**INSTRUCTION TO SERVICE ITS: 3459**

SECTION: 231  COOLING SYSTEMS	MODEL: <input type="checkbox"/> 30FT <input type="checkbox"/> 35FT <input checked="" type="checkbox"/> 40FT <input type="checkbox"/> 60FT  <input checked="" type="checkbox"/> DSL <input type="checkbox"/> CNG <input type="checkbox"/> LNG <input type="checkbox"/> ELEC	TYPE: <input type="checkbox"/> HIGH FLOOR  <input checked="" type="checkbox"/> LOW FLOOR	WRITTEN BY: Bik Dhaliwal
--	---	---	-----------------------------

Install hydraulic line PN 323837 in place of PN 279951

**Figure 1C – Hydraulic Tube Assembly**

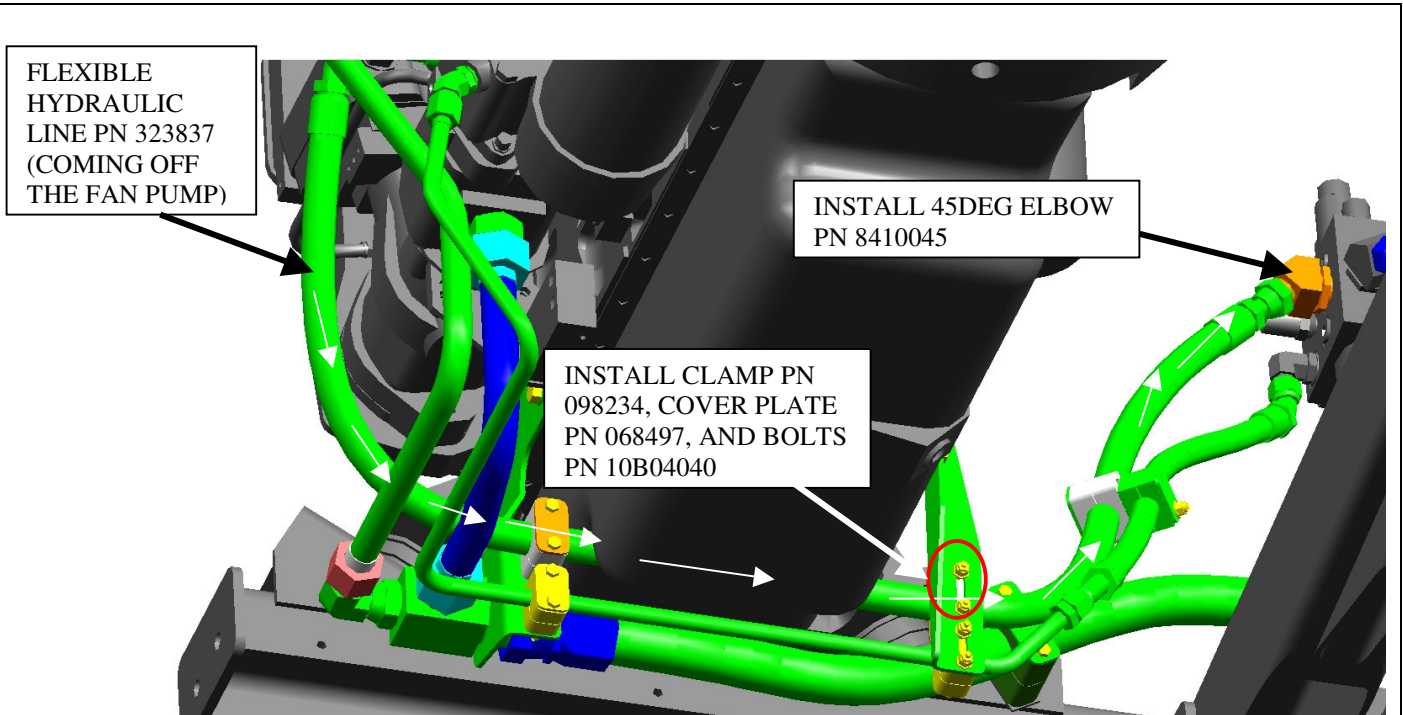
1. Turn the main battery disconnect switch to the "OFF" position.
  2. Raise coach in accordance with the New Flyer Service Manual or use a service pit.
  3. Open the rear engine access door.
- ☞ **NOTE:** Place a drip tray underneath at the ends of the hydraulic hose (NF PN 279951) and hydraulic manifold to catch any fluid runoff.
4. Remove the existing hydraulic line (NF PN 279951) on the coach and the attached hydraulic line that runs to the hydraulic manifold.
  5. Install a 45 degree elbow (NF PN 8410045) on the hydraulic manifold as depicted on Figure 1C.
